From: [Leigh Hwa](#)
To: [City of Poulsbo Planning and Economic Development](#); [Nikole CH. Coleman](#)
Subject: Public Comments Re: Pinnacle at Liberty Bay PRD and Preliminary Subdivision - REVISED Notice of Application w/Optional DNS
Date: Wednesday, June 17, 2026 3:16:42 PM

Re: Pinnacle at Liberty Bay Planned Residential Development and Preliminary Subdivision

Second Public Comment Period – PMC 18.260.070(A) Consistency Questions

CITY OF POULSBY OVERALL SITE PLAN & LOT/TRACT PHASING PLAN WASHINGTON

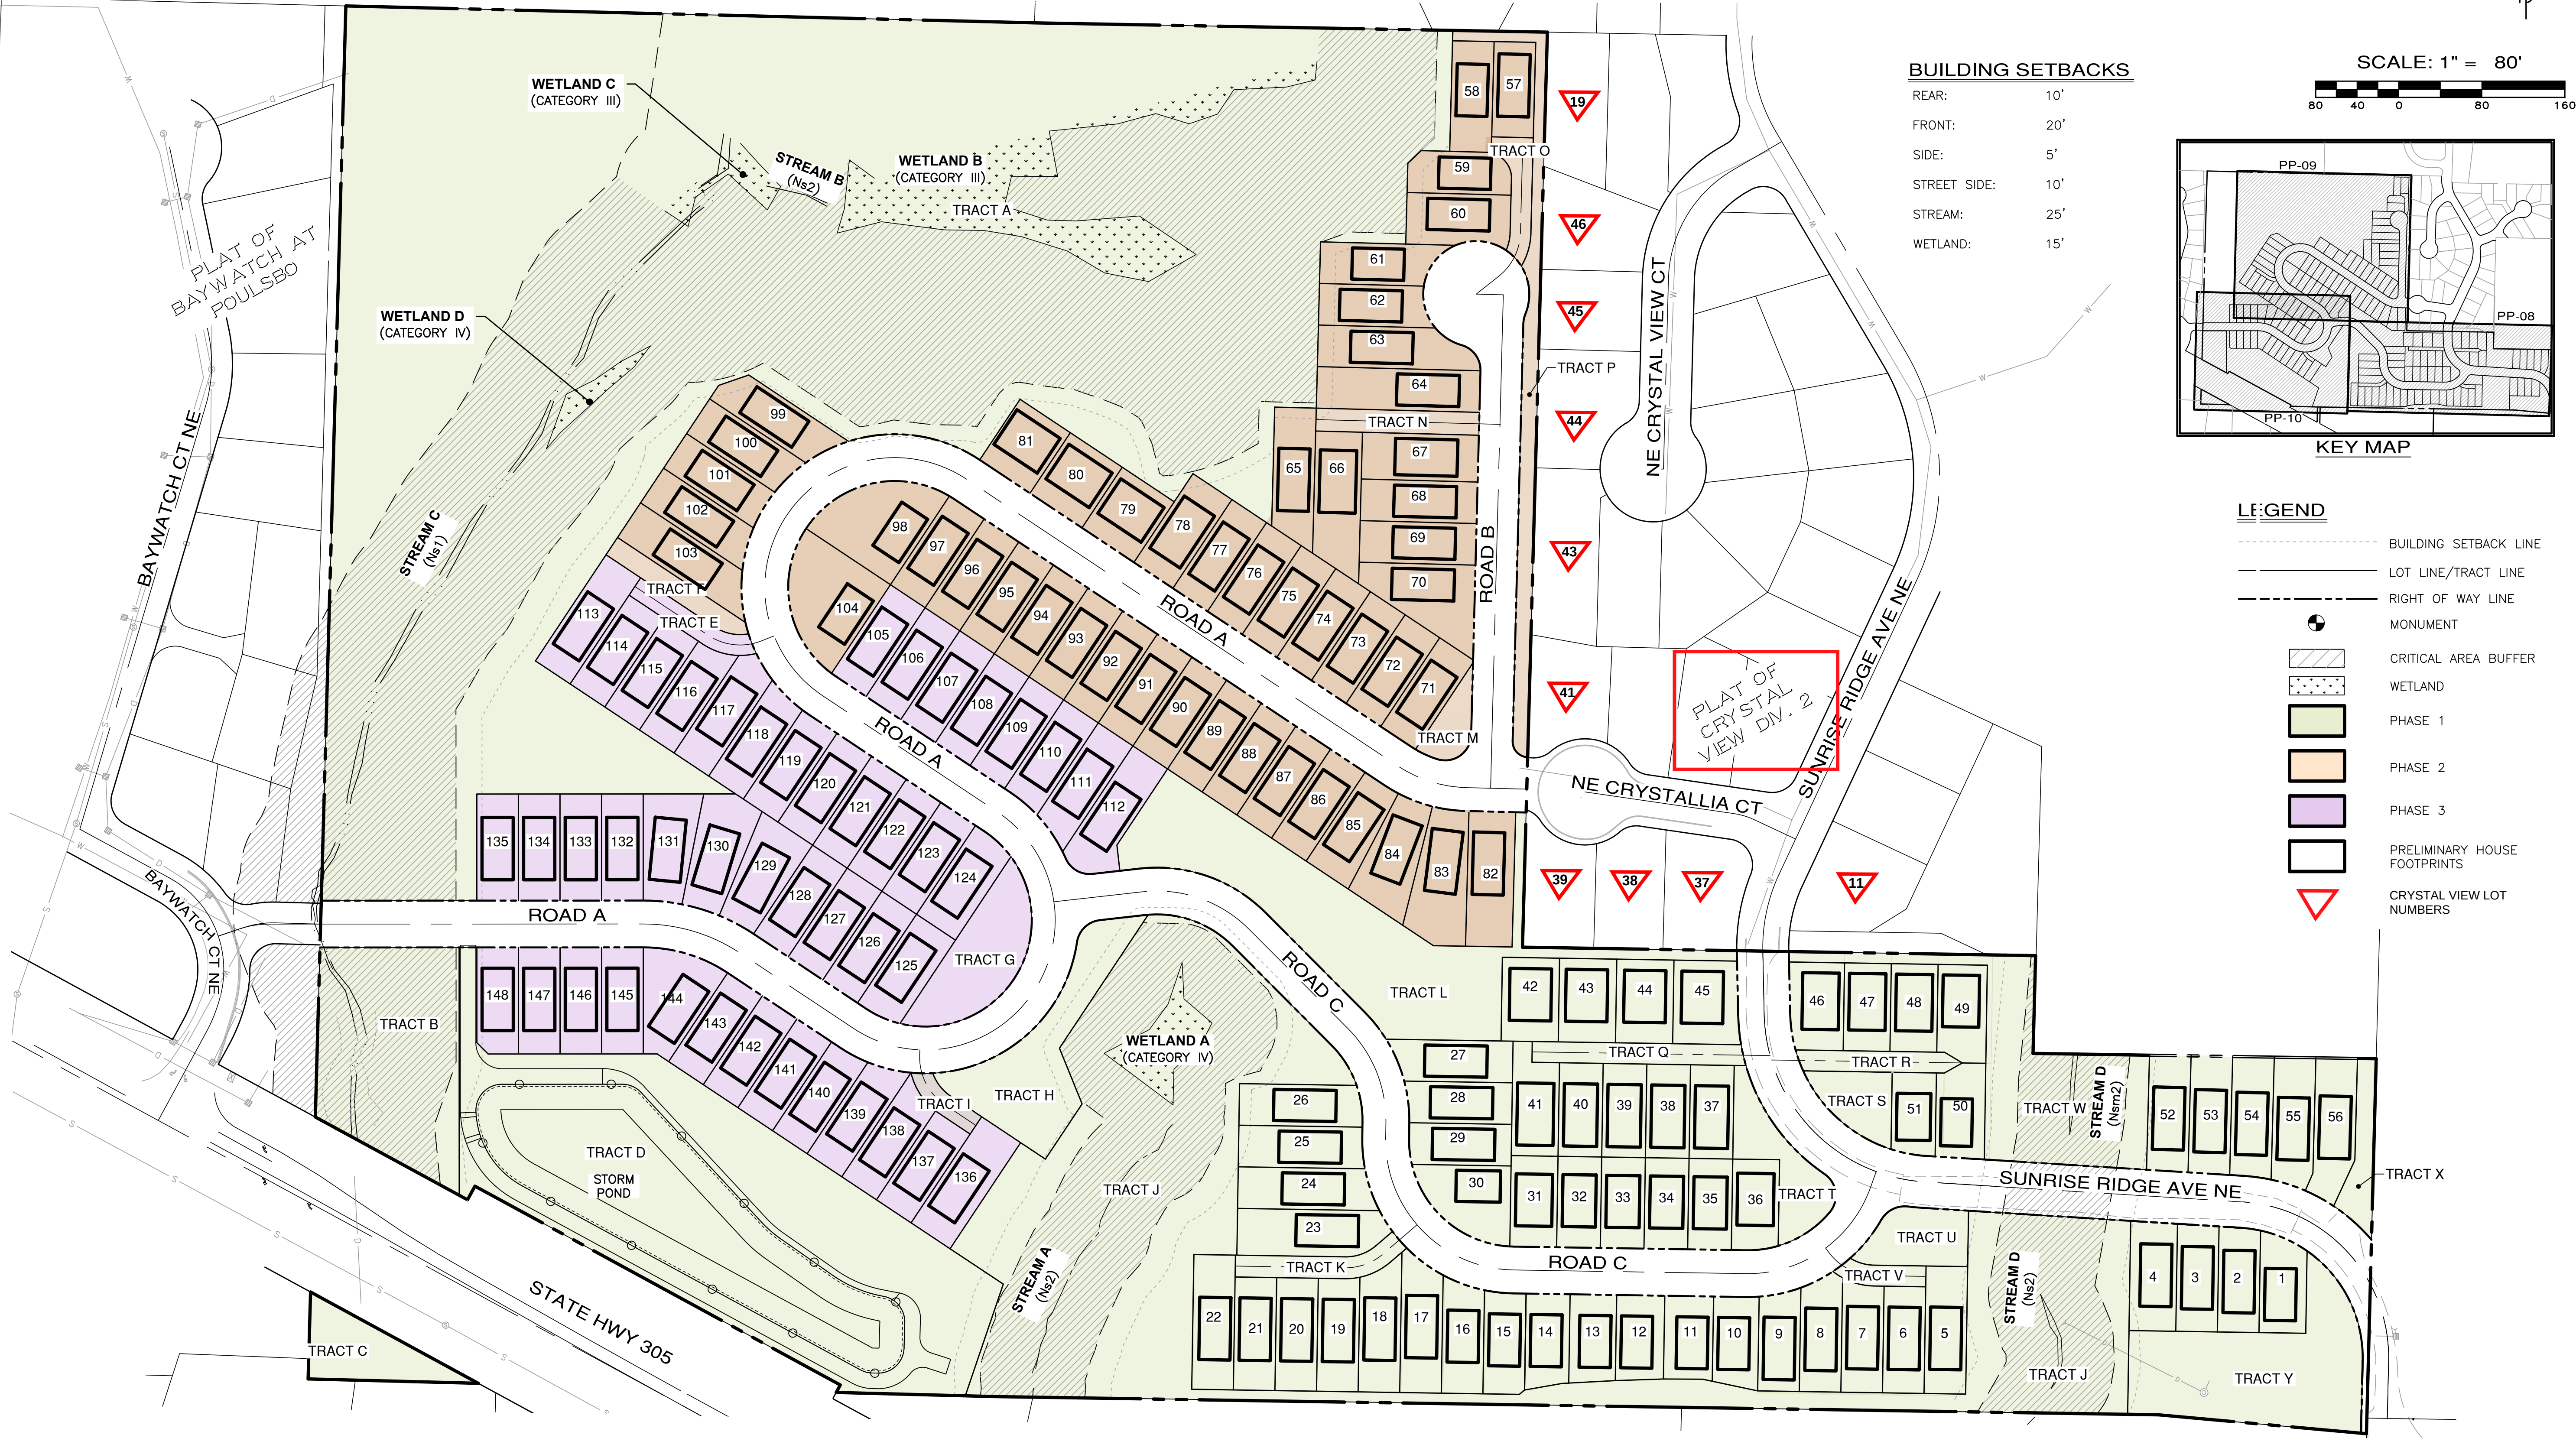
It is intended to supplement narrative comments by documenting lot pattern, density, orientation, and spatial relationships along the western and southern boundaries of Crystal View where the Pinnacle PRD abuts Crystal View. See attached civil plan drawings from the Pinnacle PRD application showing adjacency of the Pinnacle PRD to the Crystal View subdivision.

<u>Subdivision Name</u>	<u>Crystal View</u>	<u>Pinnacle at Liberty Bay</u>	Comment – Pinnacle compared to Crystal View
Length of boundary	880 ft.	880 ft.	
Number of residential lots and average size	7 – Average size: 8,545 sq. ft.	14 – Average size: 4,794 sq. ft.	Twice as many lots. 44% smaller
Lot numbers of lots facing other subdivision (north to south)	19, 46, 45, 44, 43, 41, 39 (Lot 39 is at intersection of western and southern boundaries)	57, 58, 59, 60, 61, 62, 63, 64, 67, 68, 69, 70, 71, 82	
Number of internal streets – (width in feet)	One – Crystalia Ct. (50 ft.) Joins Road A at Pinnacle PRD	One – Road A (45 ft.) Joins Crystalia Ct. at Crystal View	
Number of other access tracts	None	Tract N (22 ft. wide)	
Lots presenting narrowest dimension toward other subdivision	3 (Lots 46, 45, 44)	10 (Lots 59, 60, 61, 62, 63, 64, 67, 68, 69, 70)	Massing of narrow PRD lots facing conventional wider lots.

Average width for those lots	96.7 ft.	46.6 ft.	52% narrower
Lot setbacks – Side	5 ft. <u>minimum</u> - per Poulsbo Municipal Code 18.70.050	5 ft. <u>typical</u> - per Pinnacle PRD civil plans	Homes only 10 feet apart
Example: Lockhart Lot – No. 44	Lot size – 9,800 sq. ft. Rear property line: 114.4 ft. wide	Average for 14 lots: 4,794 Avg. width for 10 lots: 46.6 ft.	51% smaller 59% narrower

Conditions at southern boundary of Crystal View where the Pinnacle PRD is adjacent to Crystal View			
<u>Subdivision Name</u>	<u>Crystal View</u>	<u>Pinnacle at Liberty Bay</u>	Comment – Pinnacle compared to Crystal View
Length of boundary	494 ft.	494 ft.	
Number of residential lots and average size	4 – Average size: 8,100 sq. ft.	8 – Average size: 4,313 sq. ft.	Twice as many lots. 47% smaller
Lot numbers of lots facing the other subdivision (west to east)	39, 38, 37, 11 (Lot 39 is at intersection of western and southern boundaries)	42, 43, 44, 45, 46, 47, 48, 49	
Number of internal streets	One - Sunrise Ridge Ave.	One - Sunrise Ridge Ave.	Street bisects both subdivisions
Lots presenting narrowest dimension toward other subdivision	3 (Lots 39, 38, 37)	8 (Lots 42, 43, 44, 45, 46, 47, 48, 49)	Massing of narrow PRD lots facing conventional wider lots.
Average width for those lots	65.4 ft.	50.4 ft.	23% narrower

PRELIMINARY PLAT

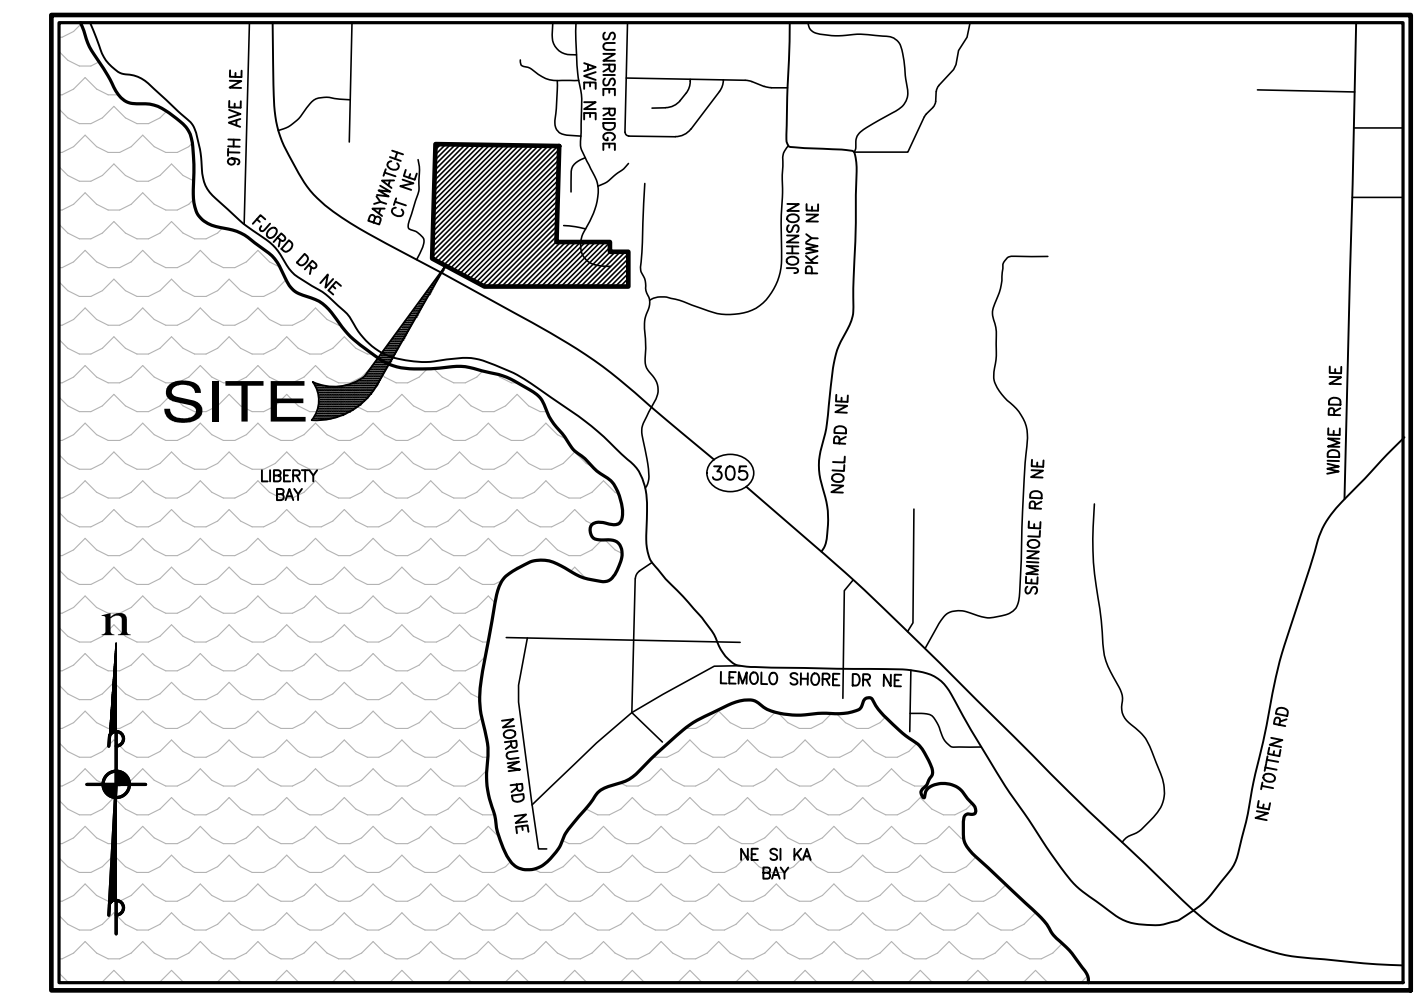
It is intended to supplement narrative comments by documenting lot pattern, density, orientation, and spatial relationships along the western and southern boundaries of Crystal View where the Pinnacle PRD abuts Crystal View. See attached civil plan drawings from the Pinnacle PRD application showing adjacency of the Pinnacle PRD to the Crystal View subdivision.

Conditions at western boundary of Crystal View where the Pinnacle PRD is adjacent to Crystal View			
<u>Subdivision Name</u>	<u>Crystal View</u>	<u>Pinnacle at Liberty Bay</u>	Comment – Pinnacle compared to Crystal View
Length of boundary	880 ft.	880 ft.	
Number of residential lots and average size	7 – Average size: 8,545 sq. ft.	14 – Average size: 4,803 sq. ft.	Twice as many lots. 44% smaller
Lot numbers of lots facing other subdivision (north to south)	19, 46, 45, 44, 43, 41, 39 (Lot 39 is at intersection of western and southern boundaries)	55, 56, 57, 58, 59, 60, 61, 62, 65, 66, 67, 68, 69, 80	
Number of internal streets – (width in feet)	One – Crystalia Ct. (50 ft.) Joins Road A at Pinnacle PRD	One – Road A (45 ft.) Joins Crystalia Ct. at Crystal View	
Number of other access tracts	None	Tract H (22 ft. wide)	
Lots presenting narrowest dimension toward other subdivision	3 (Lots 46, 45, 44)	10 (Lots 57, 58, 59, 60, 61, 62, 65, 66, 67, 68)	Massing of narrow PRD lots facing conventional wider lots.

Average width for those lots	96.7 ft.	46.7 ft.	52% narrower
Lot setbacks – Side	5 ft. <u>minimum</u> - per Poulsbo Municipal Code 18.70.050	5 ft. <u>typical</u> - per Pinnacle PRD civil plans	Homes only 10 feet apart
Example: Lockhart Lot – No. 44	Lot size – 9,800 sq. ft. Rear property line: 114.4 ft. wide	Average for 14 lots: 4,803 sq.ft. Avg. width for 10 lots: 46.7 ft.	51% smaller 59% narrower

Conditions at southern boundary of Crystal View where the Pinnacle PRD is adjacent to Crystal View			
<u>Subdivision Name</u>	<u>Crystal View</u>	<u>Pinnacle at Liberty Bay</u>	Comment – Pinnacle compared to Crystal View
Length of boundary	494 ft.	494 ft.	
Number of residential lots and average size	4 – Average size: 8,100 sq. ft.	8 – Average size: 4,214 sq. ft.	Twice as many lots. 48% smaller
Lot numbers of lots facing the other subdivision (west to east)	39, 38, 37, 11 (Lot 39 is at intersection of western and southern boundaries)	41, 42, 43, 44, 45, 46, 47, 48	
Number of internal streets	One - Sunrise Ridge Ave.	One - Sunrise Ridge Ave.	Street bisects both subdivisions
Lots presenting narrowest dimension toward other subdivision	3 (Lots 39, 38, 37)	8 (Lots 41, 42, 43, 44, 45, 46, 47, 48)	Massing of narrow PRD lots facing conventional wider lots.
Average width for those lots	65.4 ft.	48.5 ft.	26% narrower

## **Pedestrian Safety Concerns:**

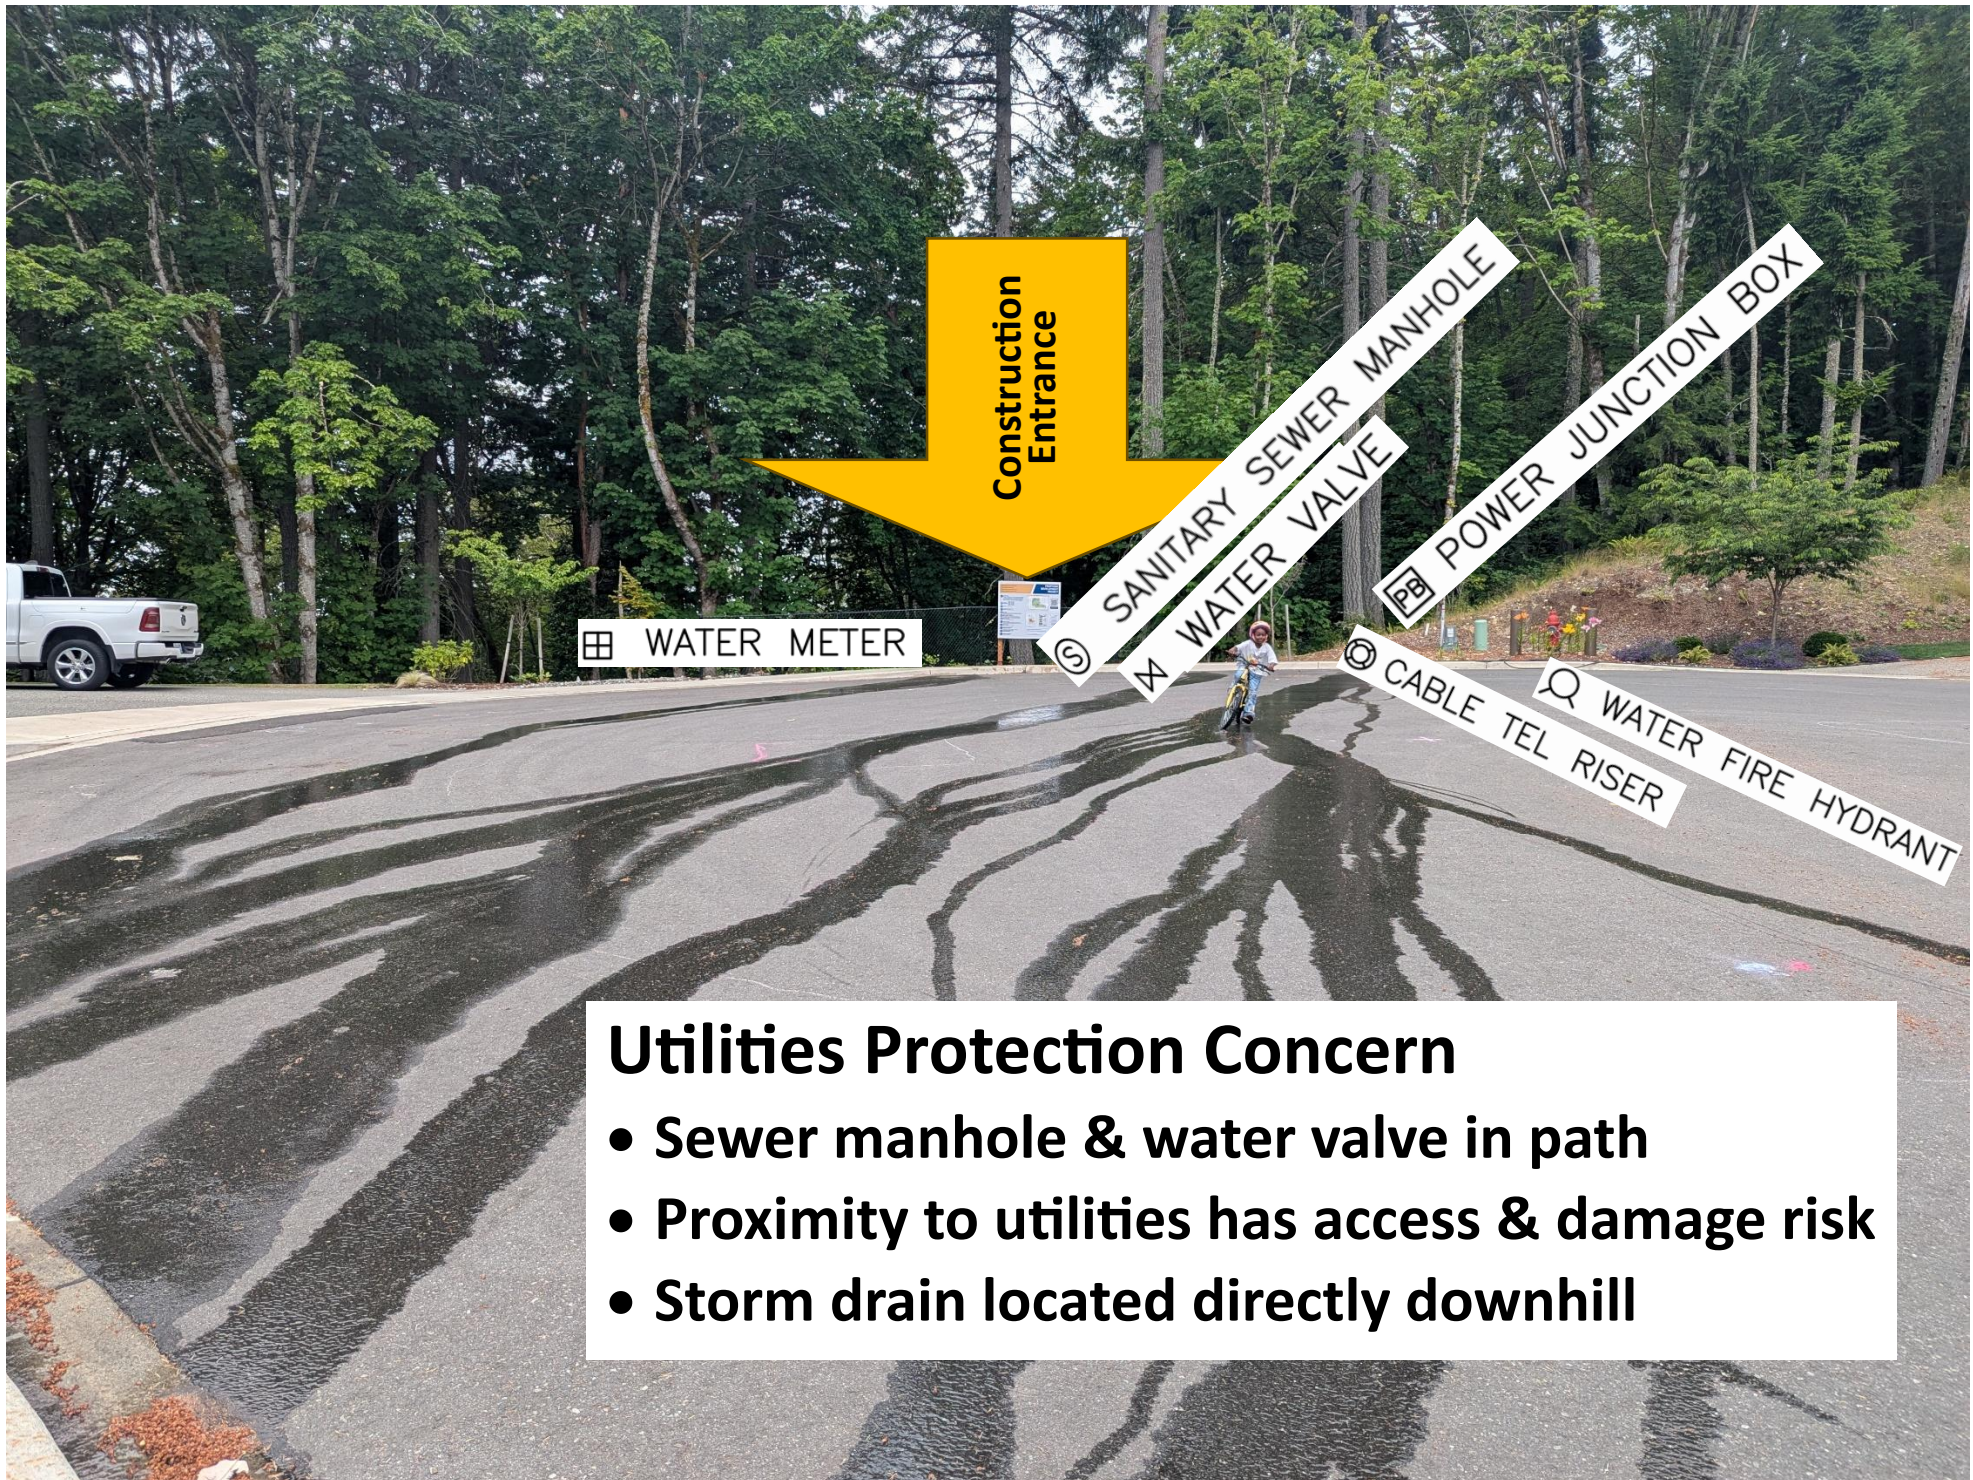
- **Crystallia Ct is highly utilized by children**
- **Poor visibility – crest of construction entrance**
- **Removal of safety fence overlapping entrance**

## **Traffic Safety Concerns:**

- **Narrow corridor for trucks when cars park**
- **Trucks create a hazard getting in/out of cars**
- **Parked cars limit visibility of kids playing nearby**
